To: Prospective Bidders  
From: Wold Architects and Engineers  
Date: July 30, 2014  
Comm. No: 133024

Subject: **Addendum No. 3** for Bidding Documents for the: **Courthouse Renovations Phase I & II**

This addendum forms a part of the Contract Documents dated July 3, 2014. Acknowledge receipt of this Addendum on the space provided on the Bid Form. Failure to do so may result in disqualification of Bid.

### 7. SHEET M0.01 – BASEMENT MECHANICAL DEMOLITION PLAN

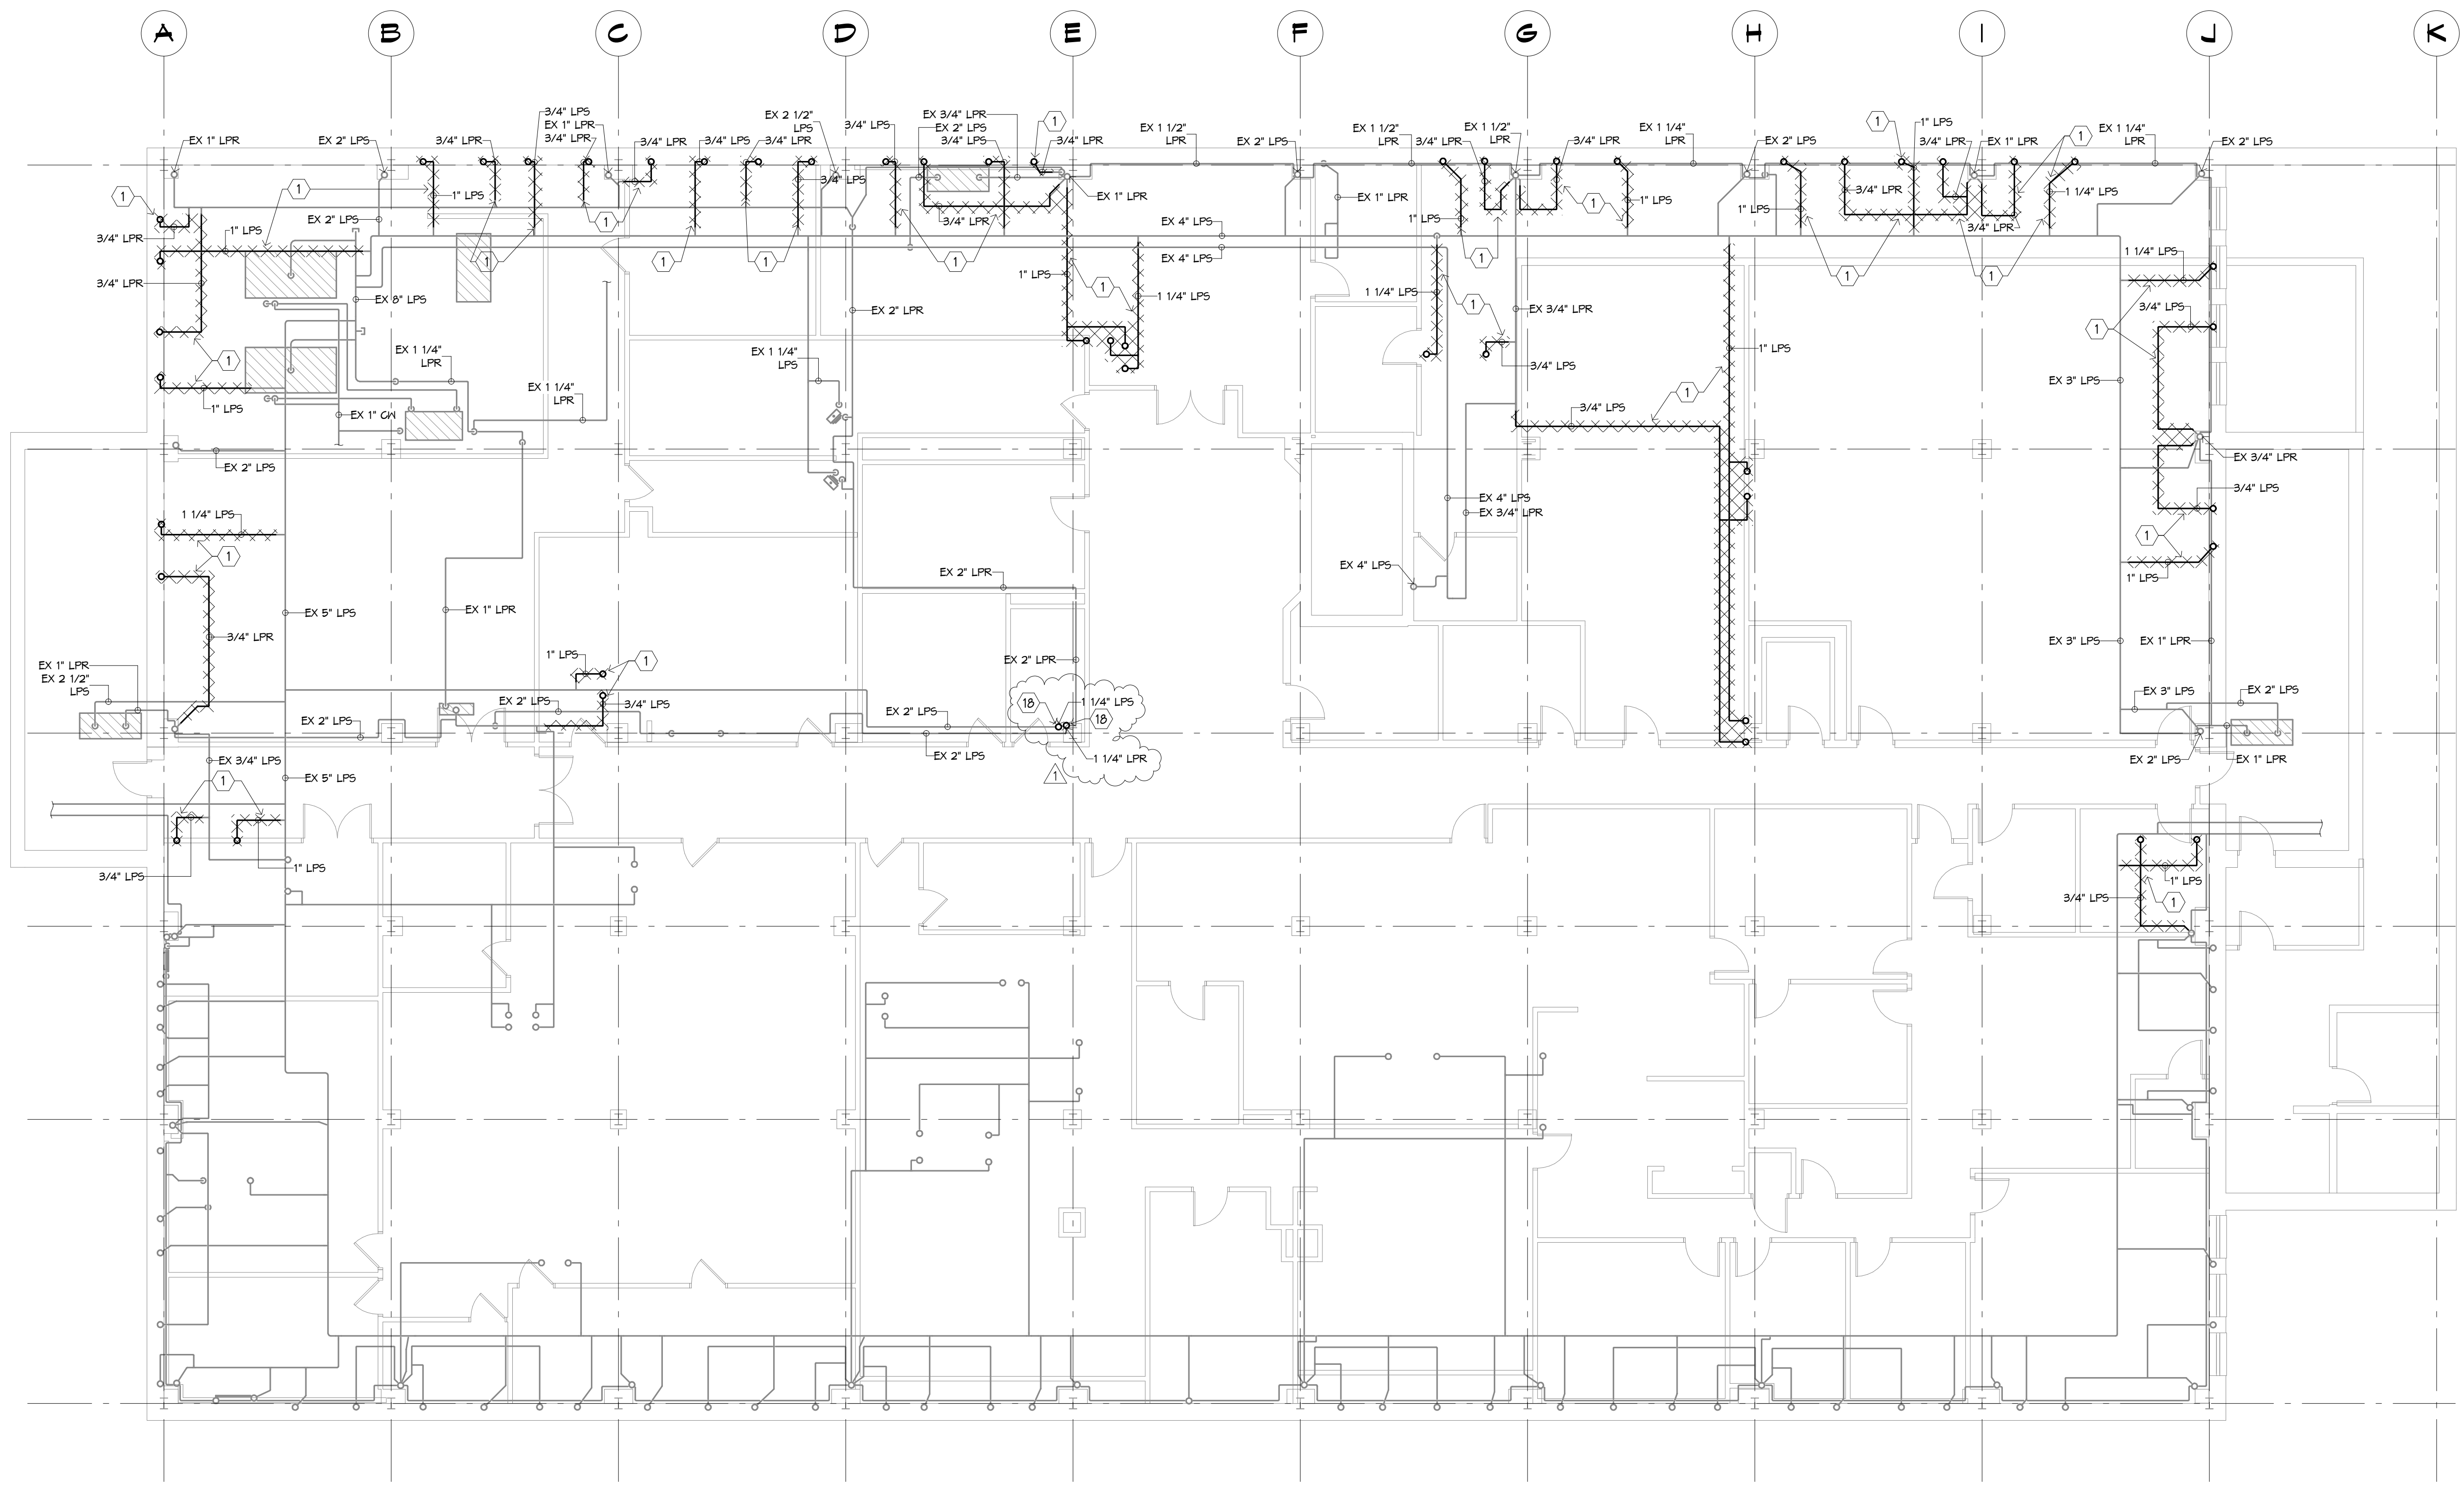
A. Refer to attached Sheet M0.01 for revised condensate drain piping demolition.

**MAIN LEVEL  
MECHANICAL  
DEMOLITION PLAN**

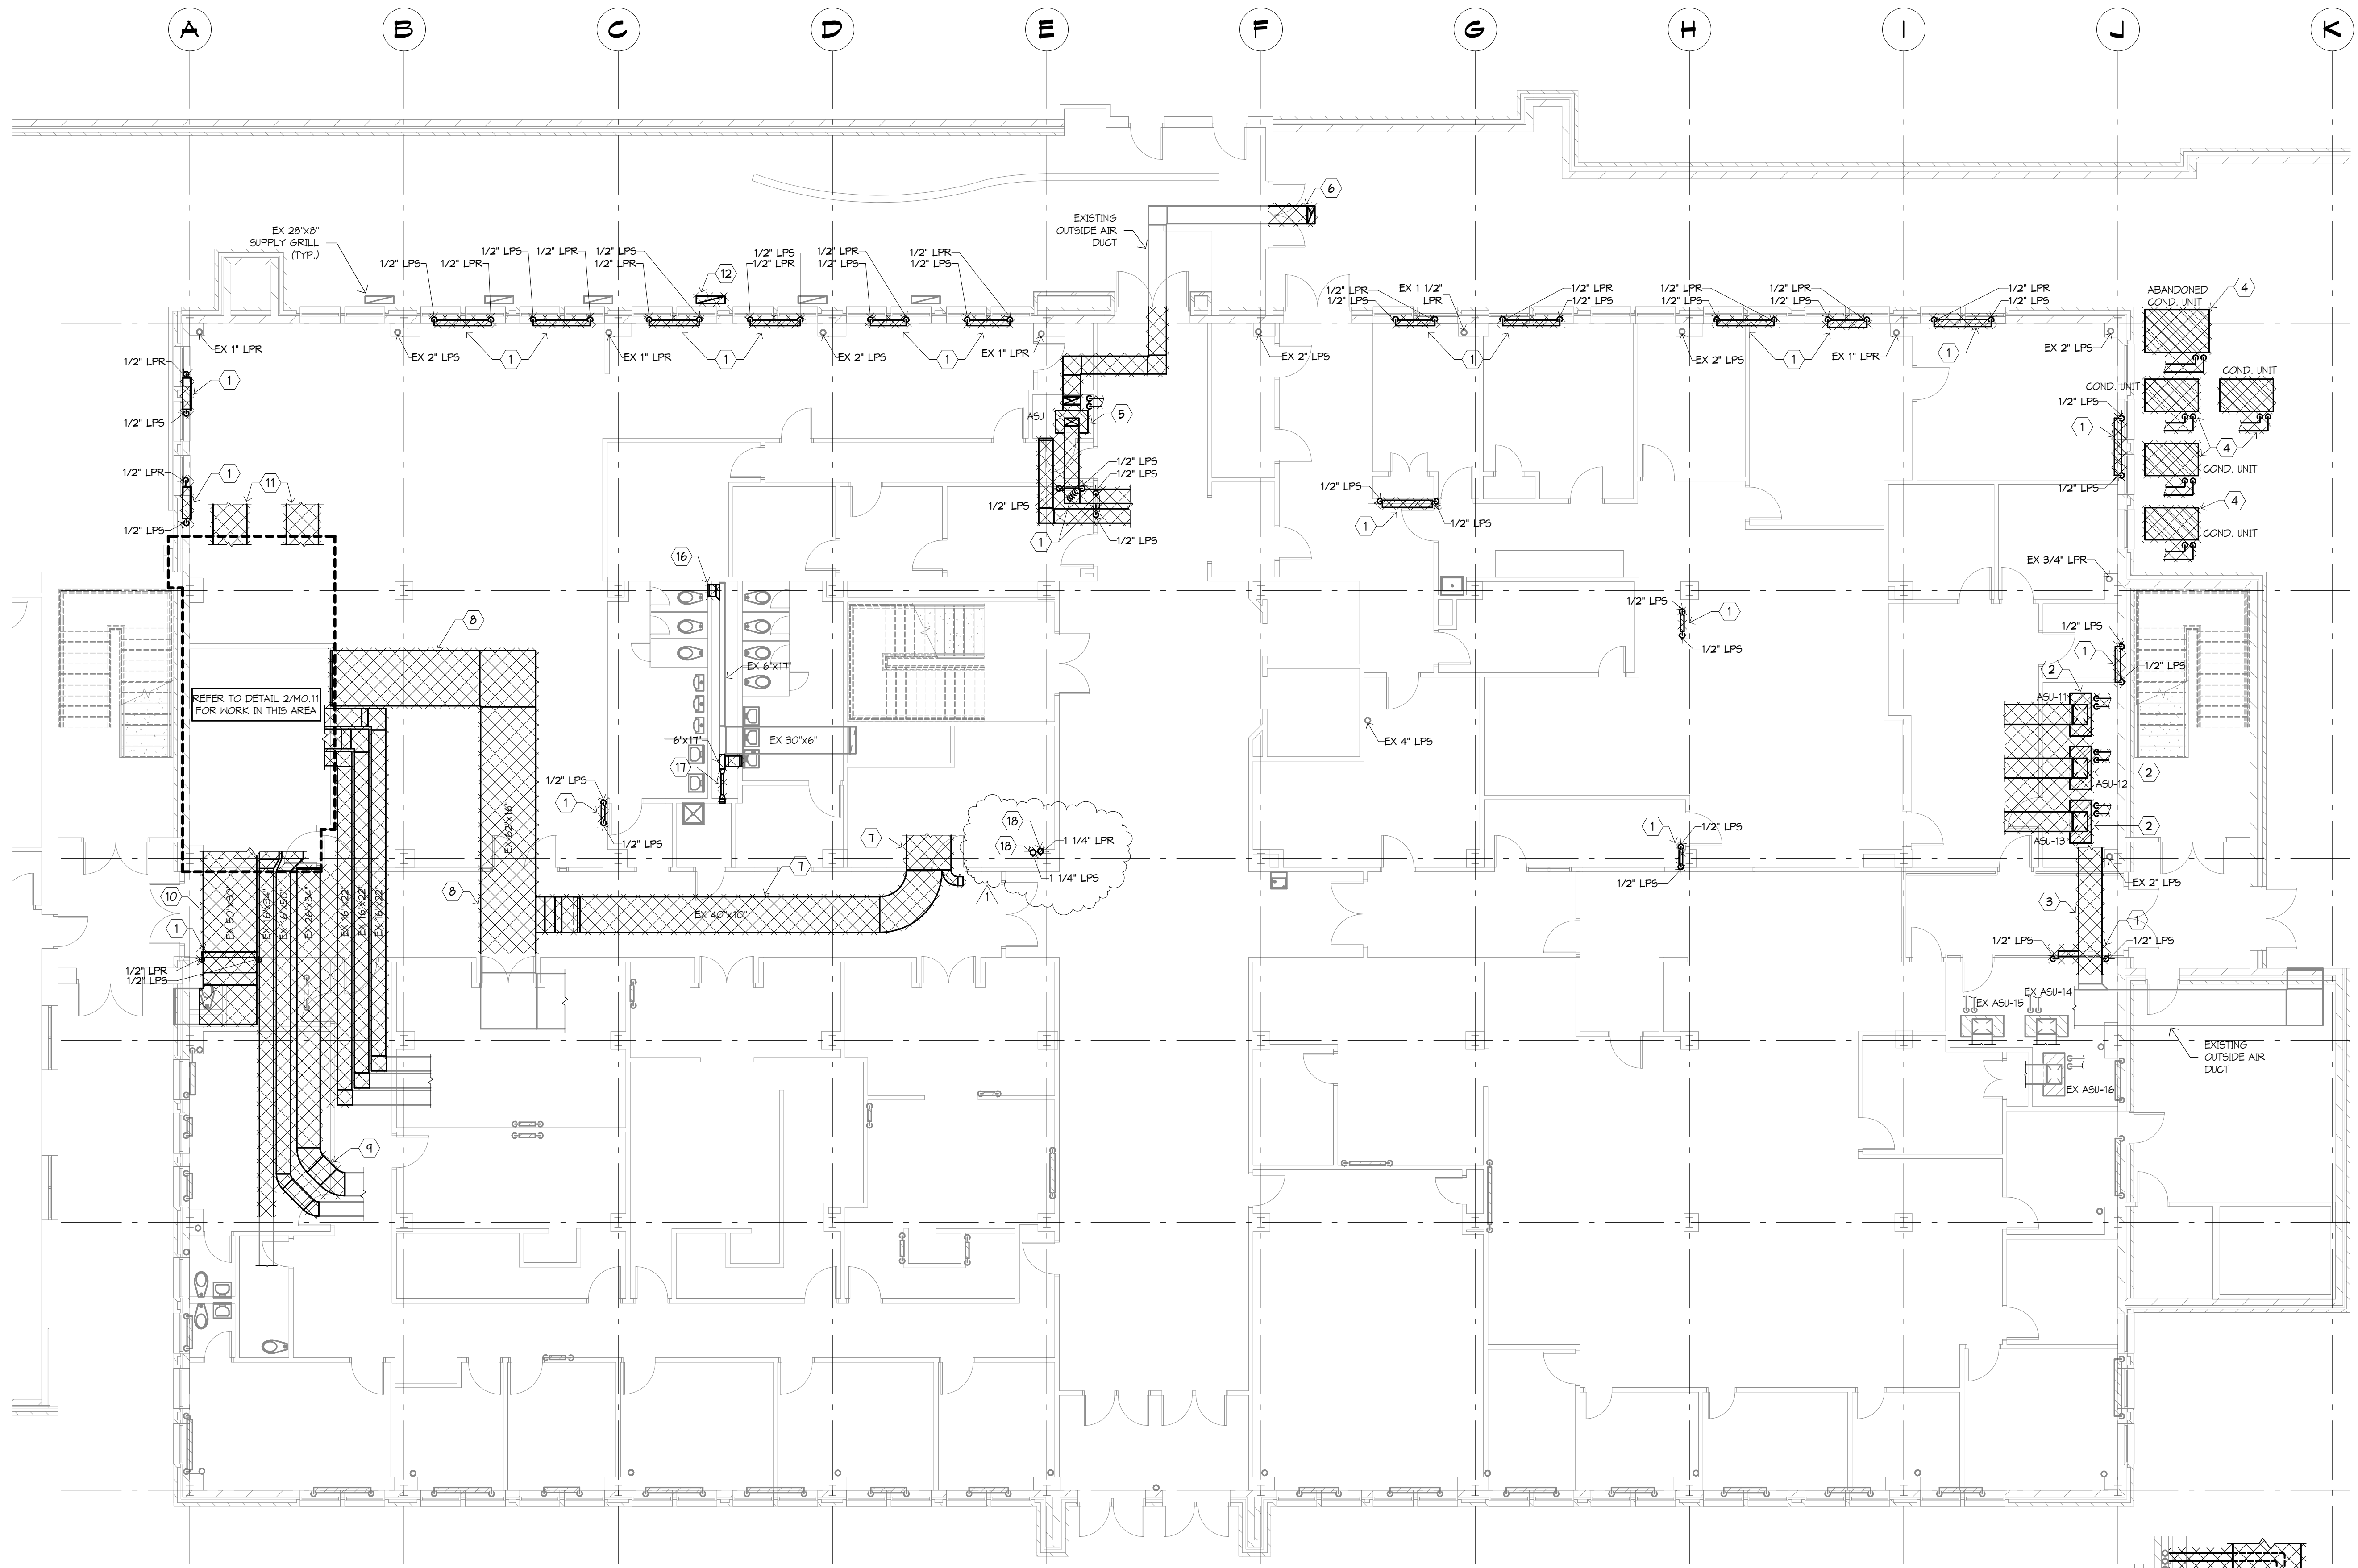
8. **SHEET M0.11 – MAIN LEVEL MECHANICAL DEMOLITION PLAN**  
A. Refer to attached Sheet M0.11 for revised condensate drain piping demolition.
9. **SHEET M1.01 – BASEMENT HYDRONIC PIPING, BOILER ROOM, AND BAS PLAN**
